## **REGIONAL REVIEW FINDING**

**RE:** Development of Regional Impact (DRI) Review

Name of Proposal: 2023 The Gathering at South Forsyth DRI 3967

DRI 02

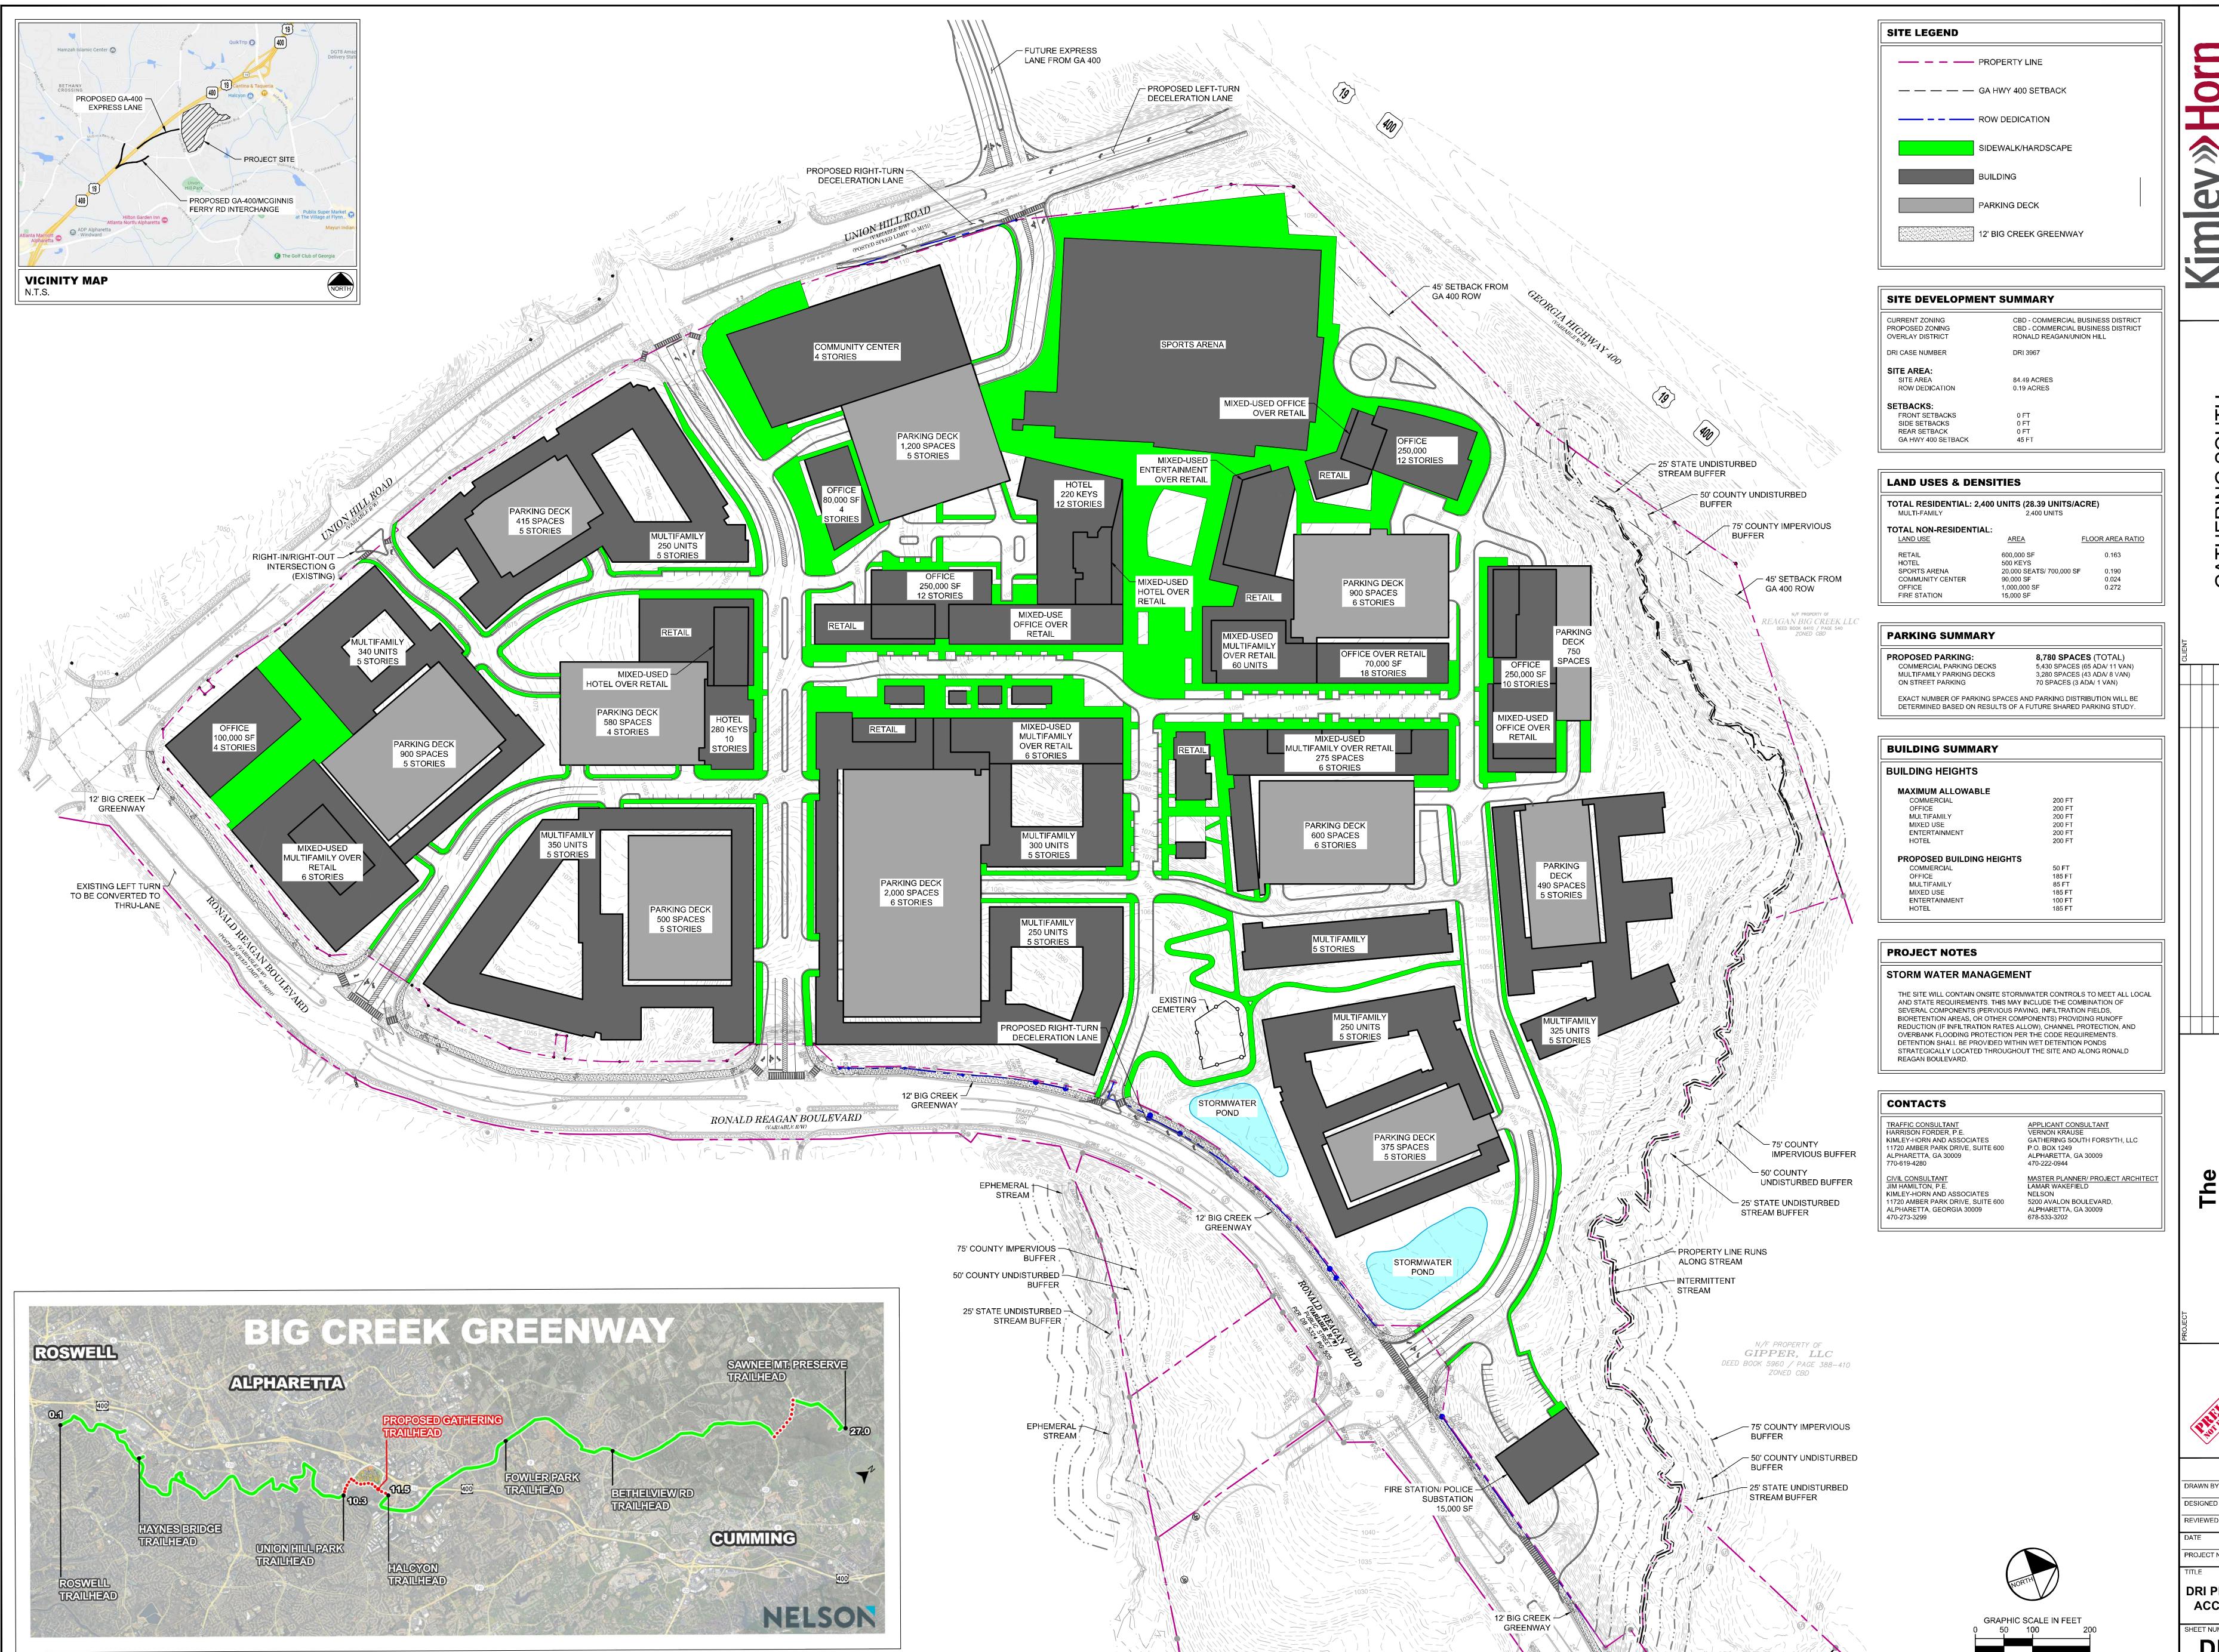
The project includes an extensive internal sidewalk network and the provision of a 12-ft wide segment of the Big Creek Greenway along the Ronald Reagan Boulevard frontage which are supportive of regional altmode transportation policies.

Care should be taken to ensure that the development promotes an interconnected, functional, clearly marked and comfortable pedestrian experience on all streets, paths, entrances, and parking areas. To the maximum extent possible, new driveways and intersection corners where pedestrians will cross should be constructed with minimal curb radii to reduce speeds of turning vehicles and decrease crossing distances for pedestrians.
